**PHAP15-00037**

**Date:** September 14, 2015  
**Application Type:** Certificate of Appropriateness  
**Property Owner:** Maria, Lilia, and Andres Favela  
**Representative:** Andres Favela  
**Legal Description:** Being 1 Mundy Heights 3 To 6, City of El Paso, El Paso County, Texas  
**Historic District:** Sunset Heights  
**Location:** 209 Lawton Street  
**Representative District:** #8  
**Existing Zoning:** R-4/H (Residential/Historic)  
**Year Built:** 1928  
**Historic Status:** Contributing  
**Request:** Certificate of Appropriateness for the construction of a secondary garage and the removal and replacement of windows after-the-fact  
**Application Filed:** 9/3/2015  
**45 Day Expiration:** 10/18/2015

**ITEM #3**

Certificate of Appropriateness for the construction of a secondary garage and the removal and replacement of windows after-the-fact

## SITE PLAN

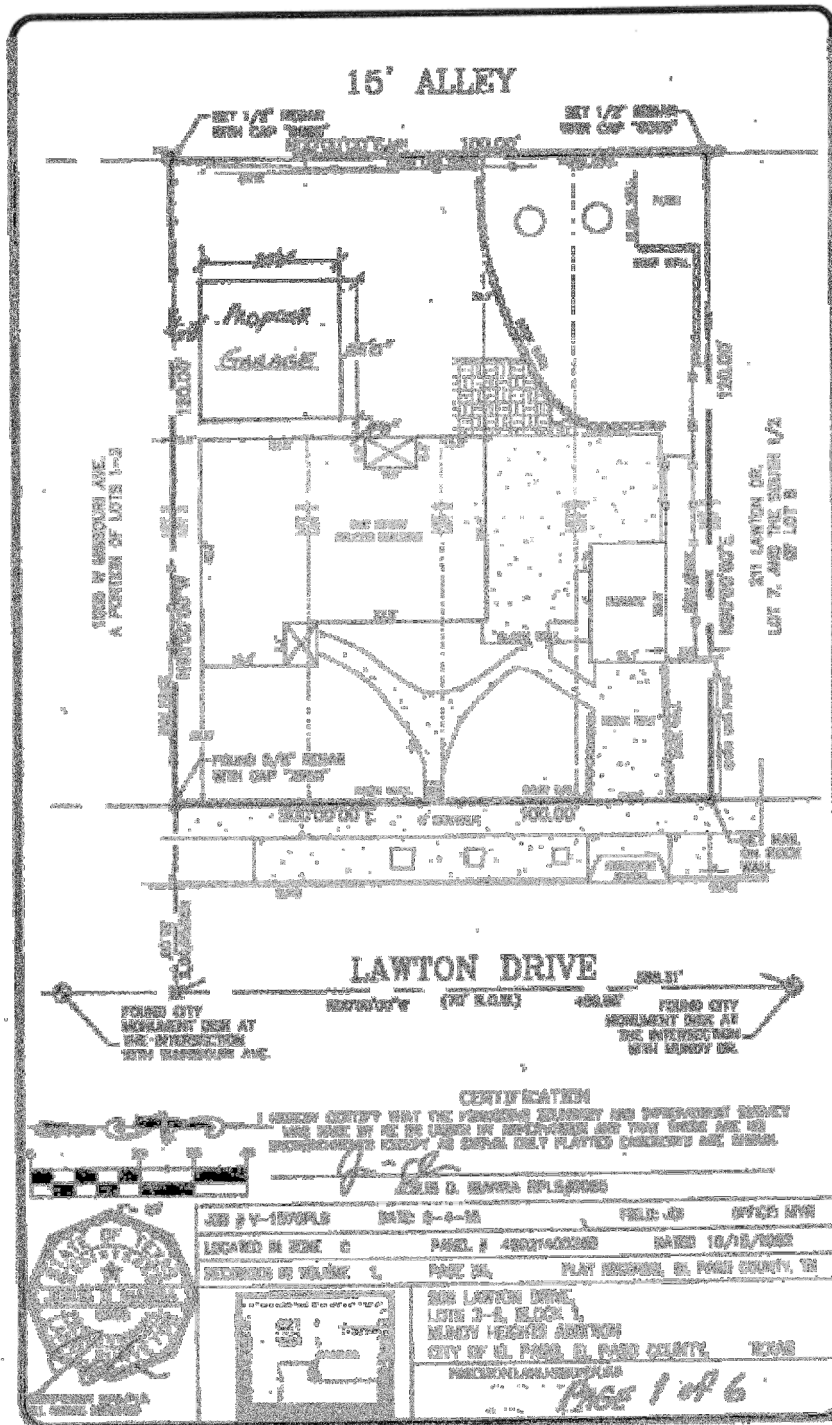
*The modifications are that the garage be moved back one foot so that it is five feet away from the main structure; that the replacement windows be removed and replaced with windows that replicate the original windows in type, style, operation, configuration and finish; that no permits for the new construction be issued until the replacement windows have been installed and are in compliance; and that the new windows be installed within ninety (90) days.*
